GLENEAGLE GOLF COURSE RESIDENTIAL INFILL DEVELOPMENT, FIL #2

DRAINAGE, GRADING & EROSION CONTROL PLAN OVERALL

GLENEAGLE
 SUBDIVISION FIL #2

DRAINAGE, GRADING &
 EROSION CONTROL
 PLAN

C
SHEET 3

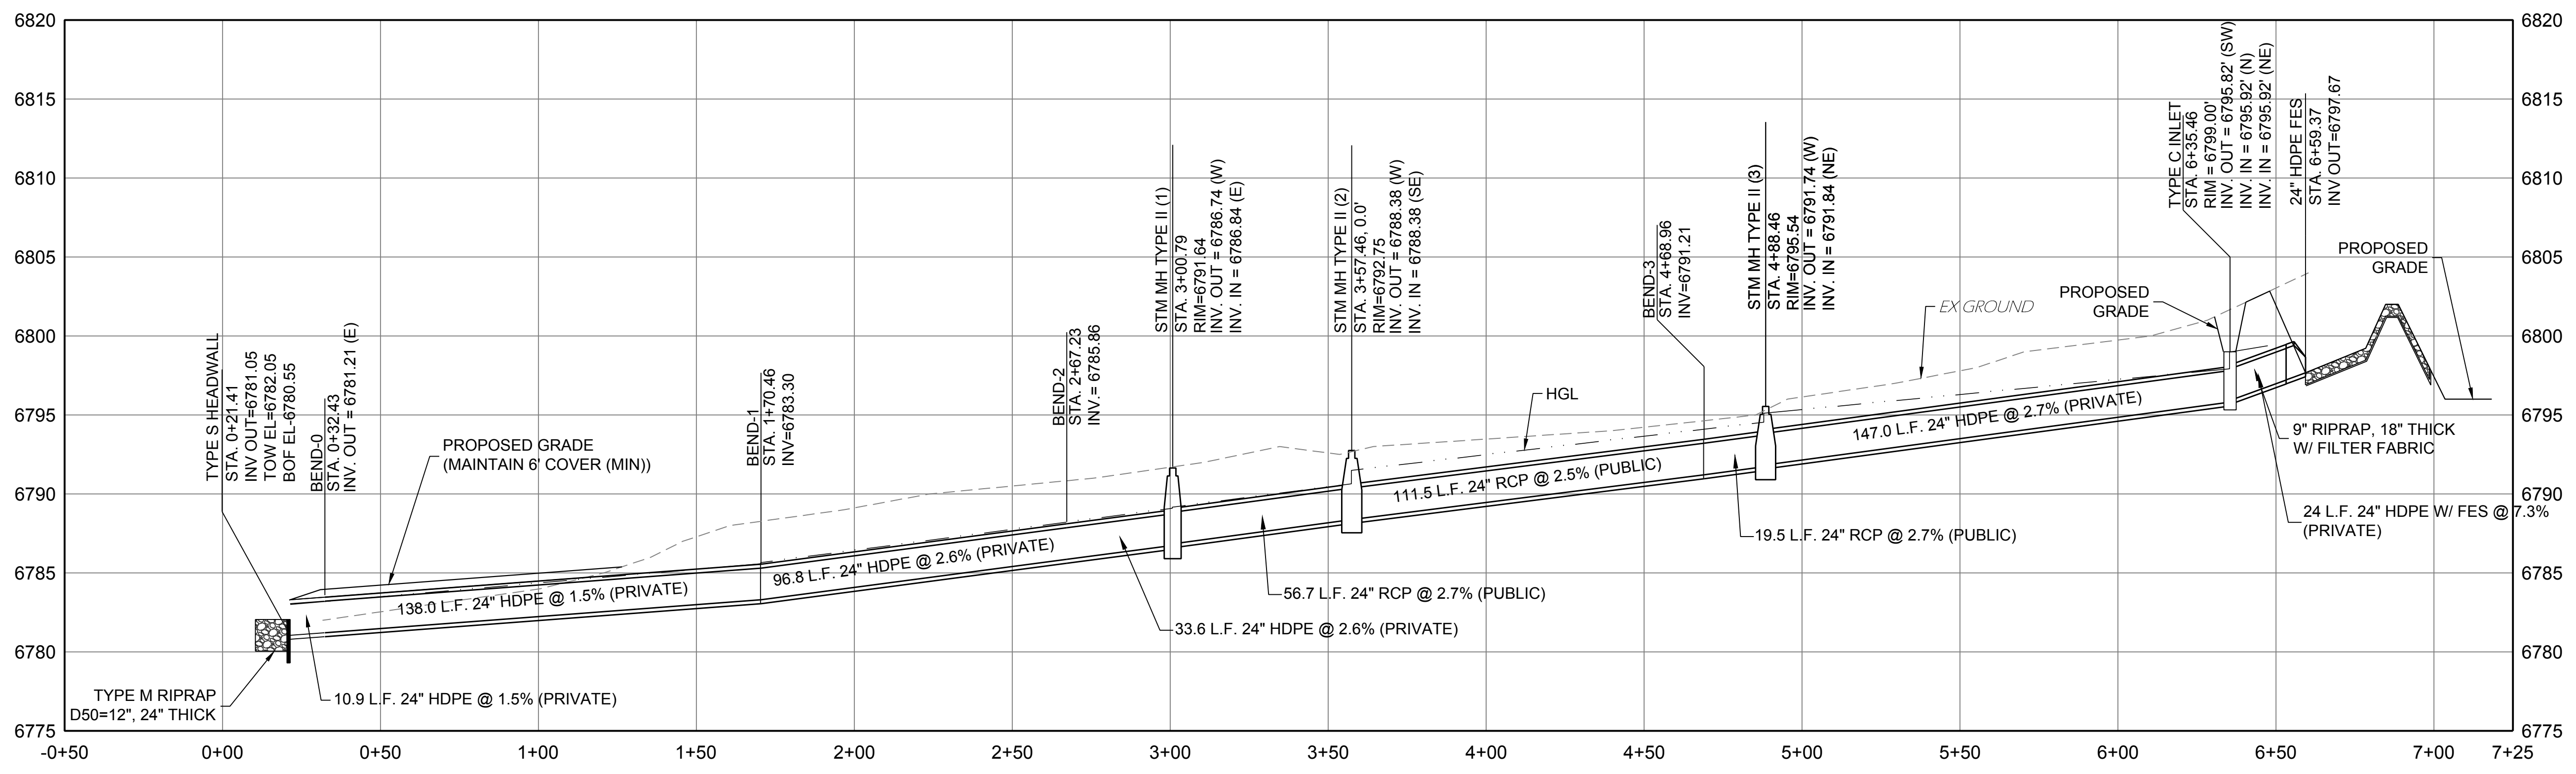
Please include Storm Sewer Plans on the Construction Plan set.
